## Addendum No. #02

January 4, 2024

Meadow Heights MP Building INC-2  
2619 Dolores St.  
San Mateo, CA 94403  
DSA#: 01-120018 INC-2

MECHANICAL FLOOR PLAN - AIR DISTRIBUTION  
1 SCALE: 1/8" = 1'-0"

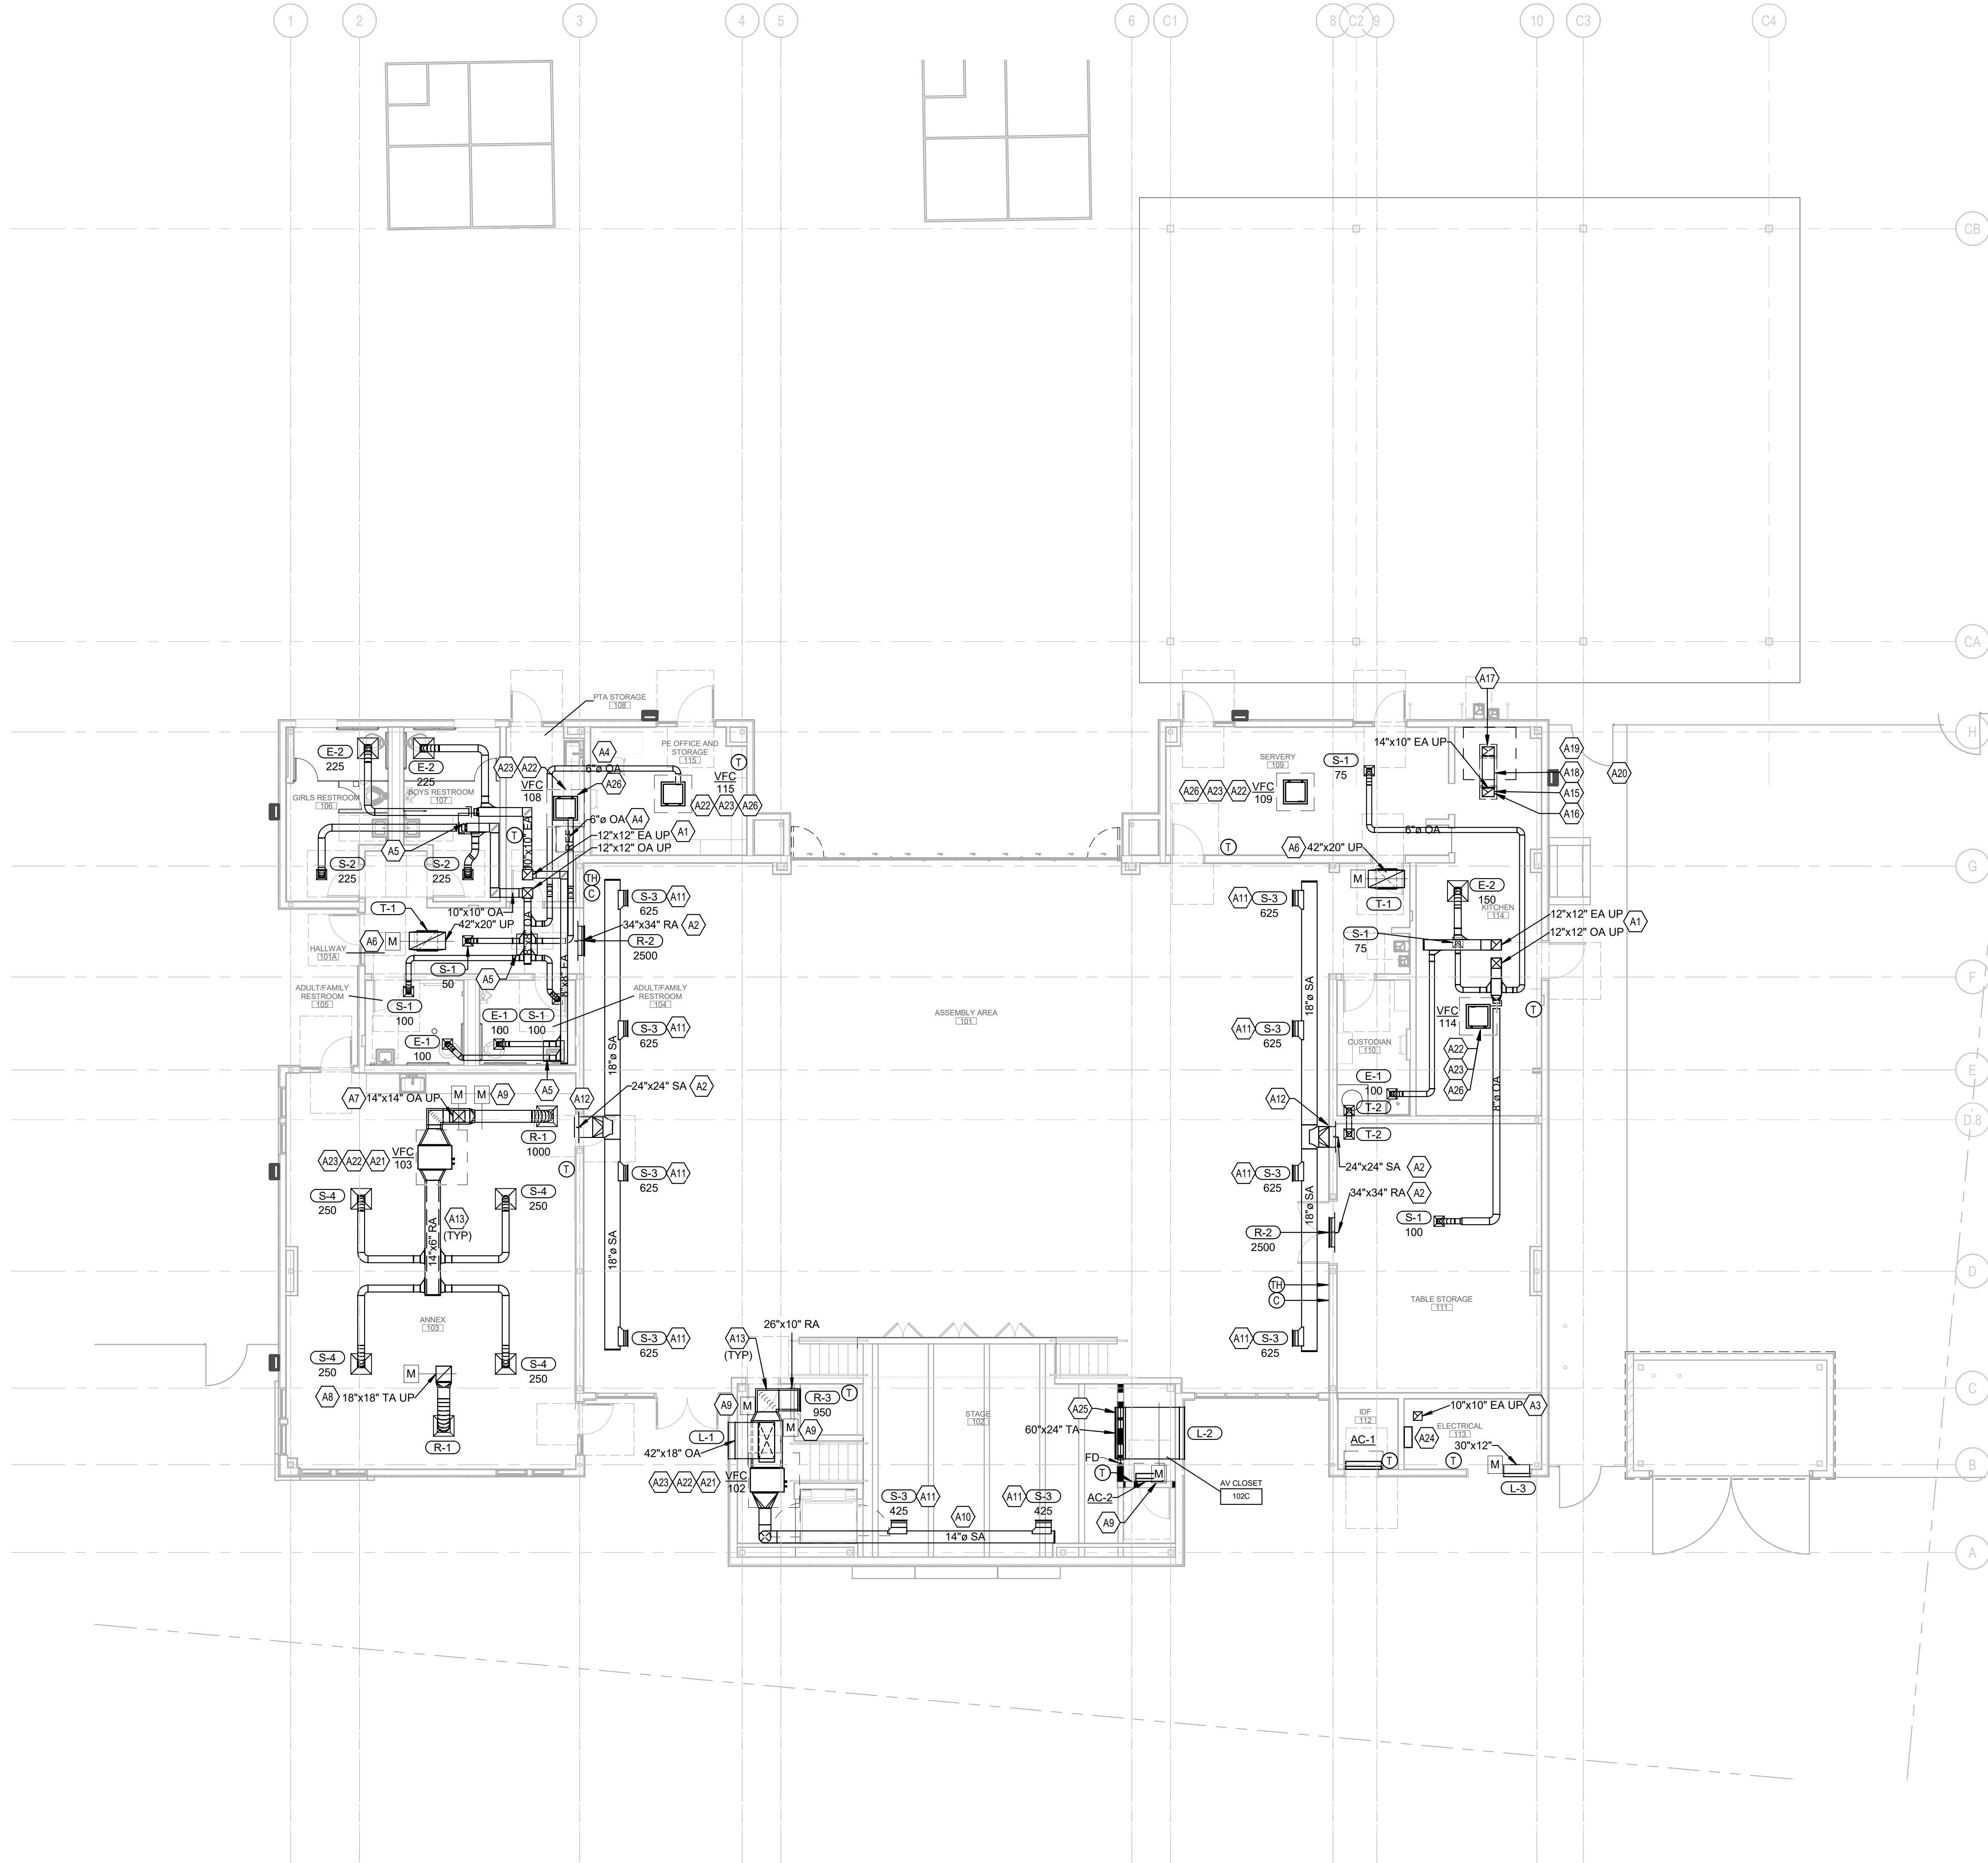
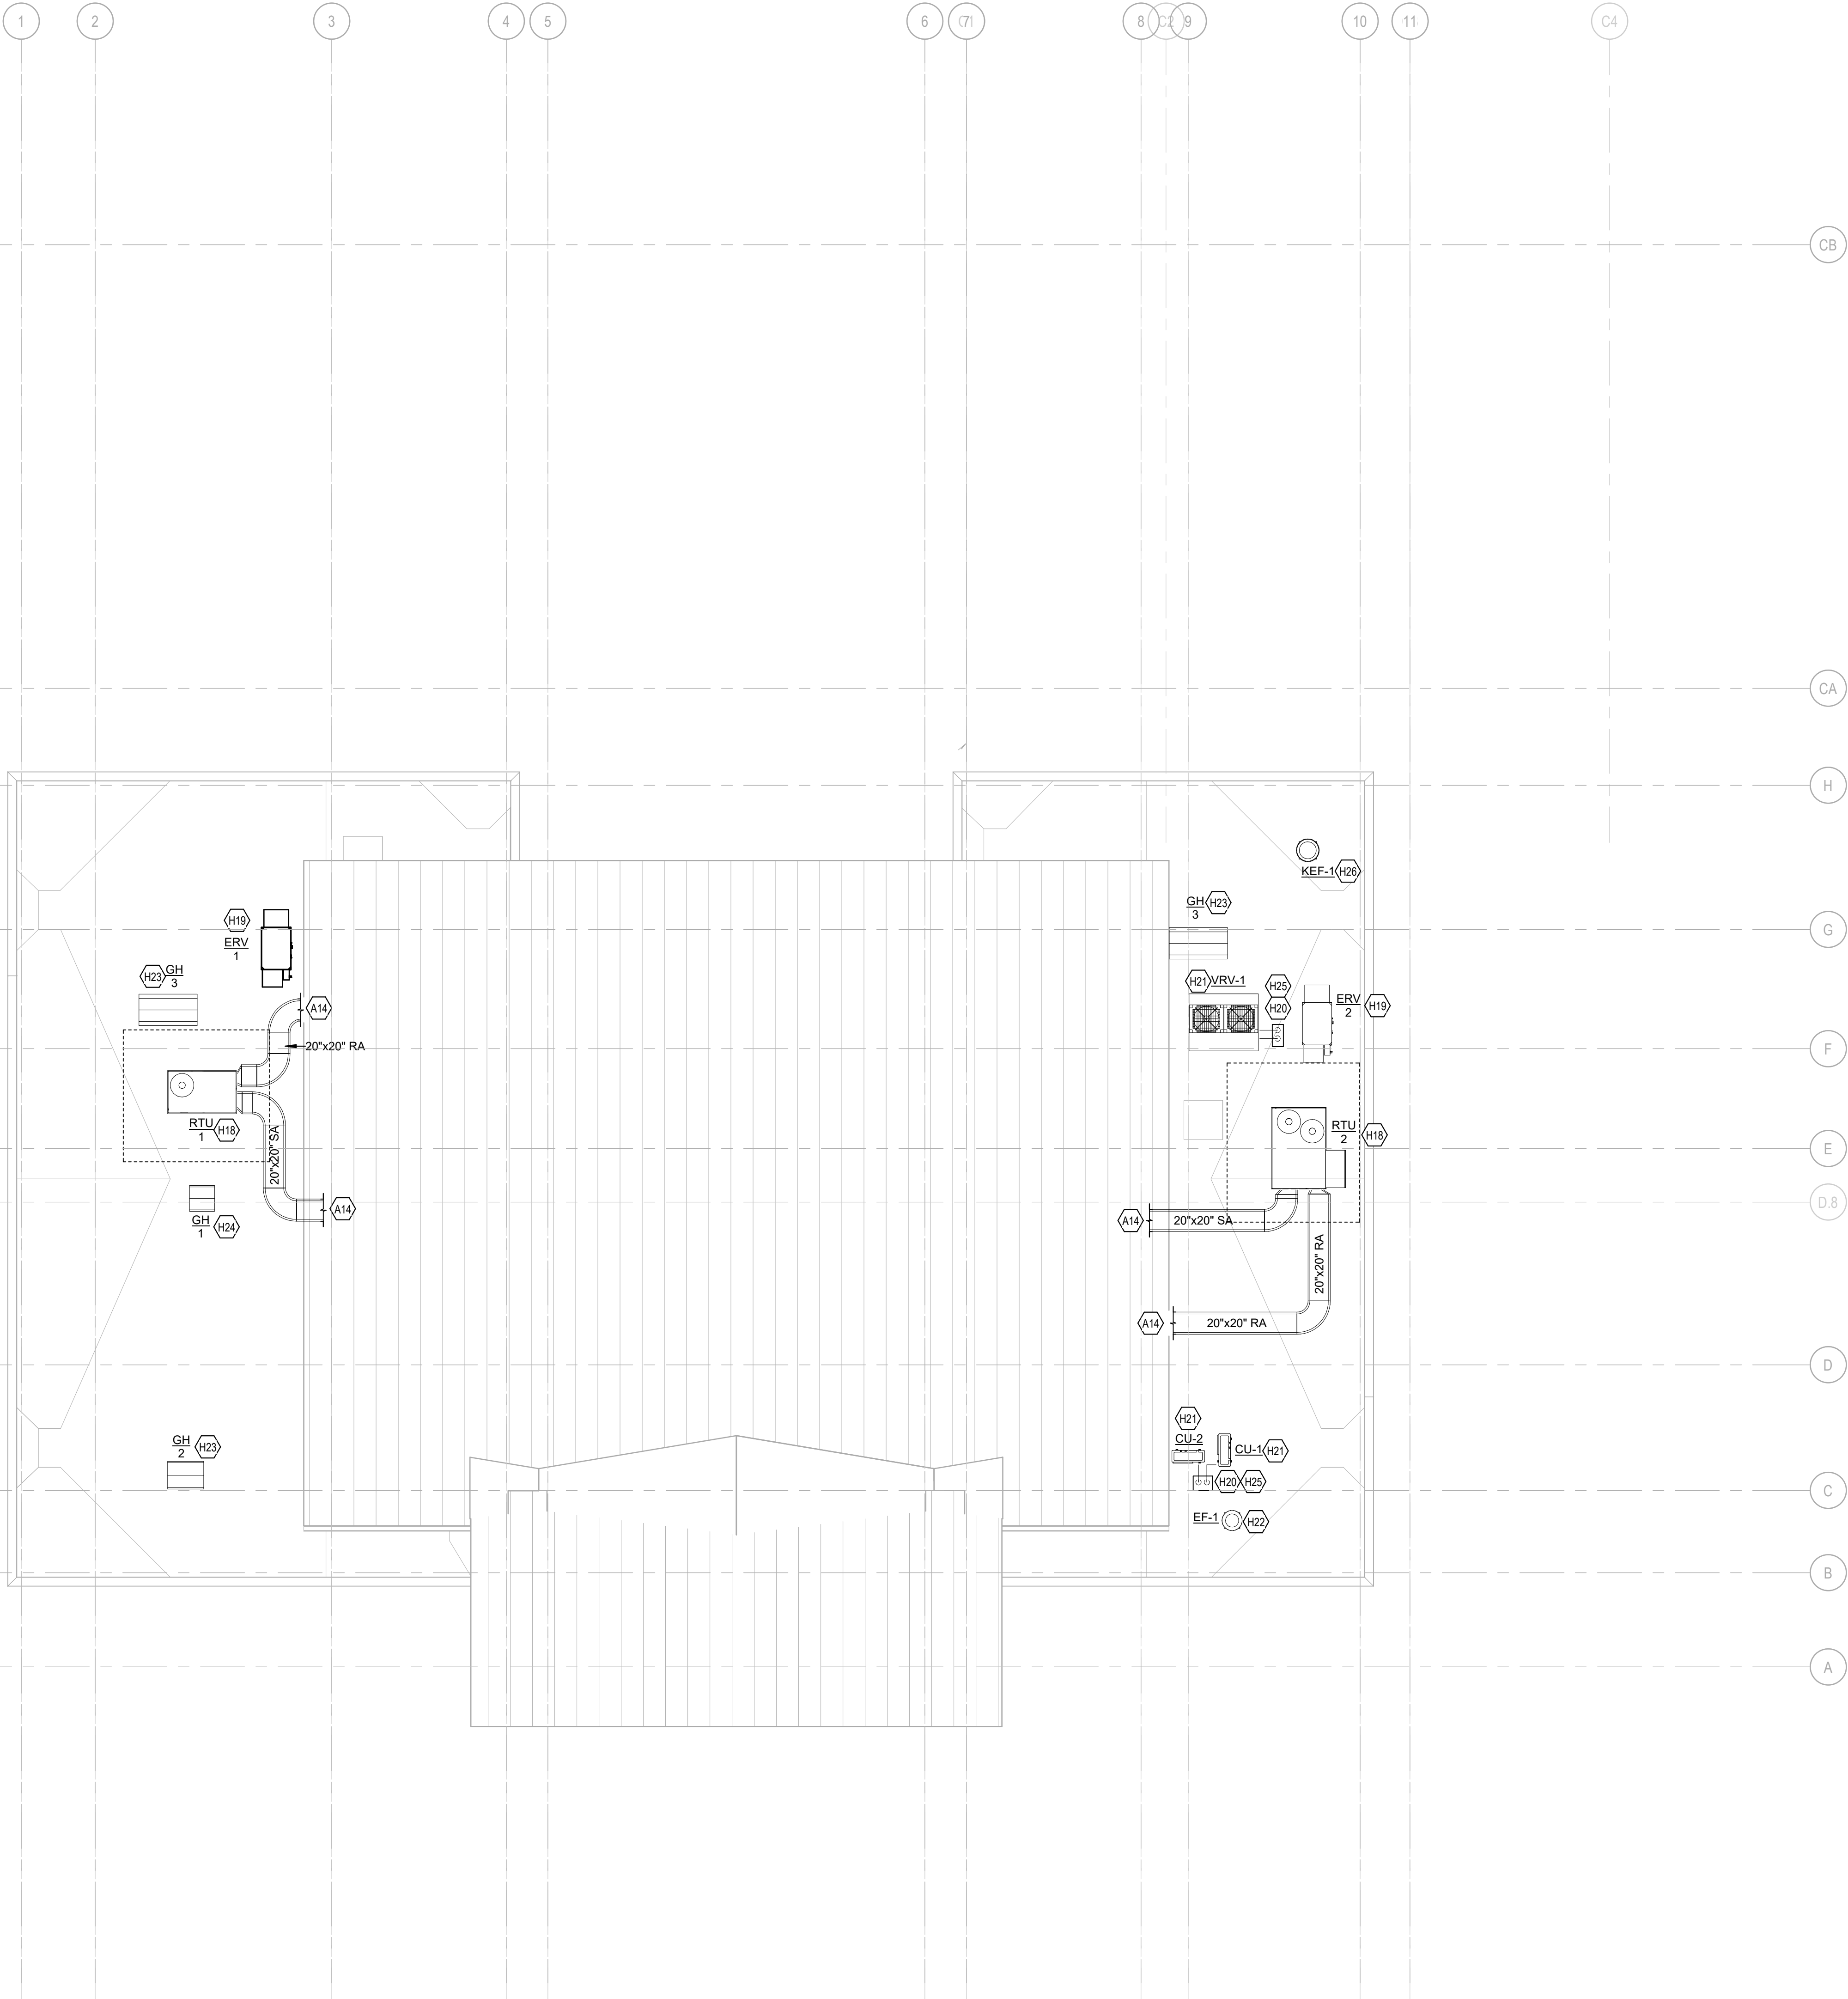
12. **Question:** On sheets M-100 and M-102 there are missing key notes that show on drawings but not listed. Can we get this information? (A17, A19, H23,H118 etc.)

13. **Question:** On sheet M-100 the 10" x 10" exhaust drop-in electrical room 113, how is this being terminated? with a grill, cap with mesh?

**Answer:** Keynotes have been updated and added to sheets. See attached 2.M100 and 2.M102

**Answer:** Terminate with metal mesh bird screen

#### 7 ROOFTOP DUCT SUPPORT DETAIL

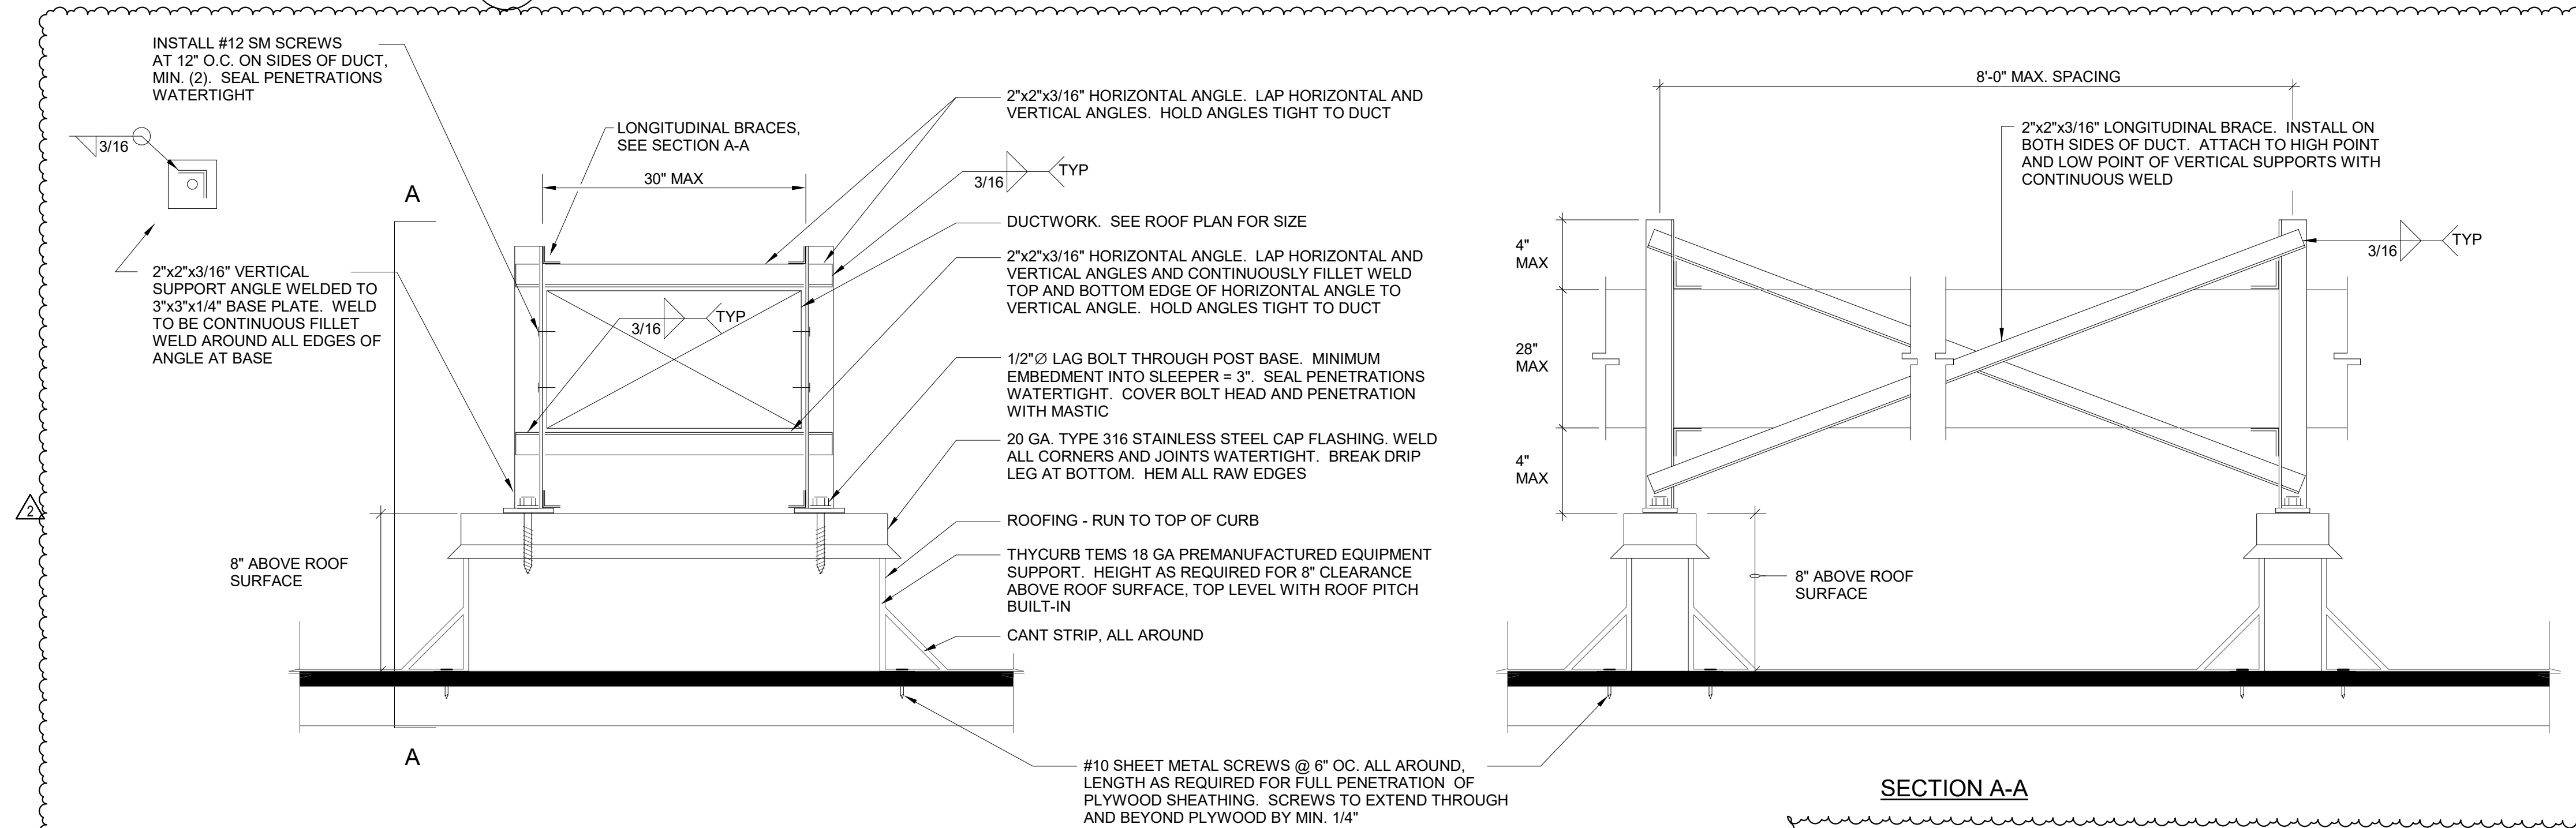
16. **Question:** On sheet 2.M102 keynote A14 how does this support detail apply to ductwork? This detail seems to be towards the piping trades.?

17. **Question:** Will there be any roof duct supports details? I assume there will be some to support this ductwork.

**Answer:** Refer to roof duct support details on sheet 2.M201 added in addendum 2

**Answer:** Refer to roof duct support details on sheet 2.M201 added in addendum 2
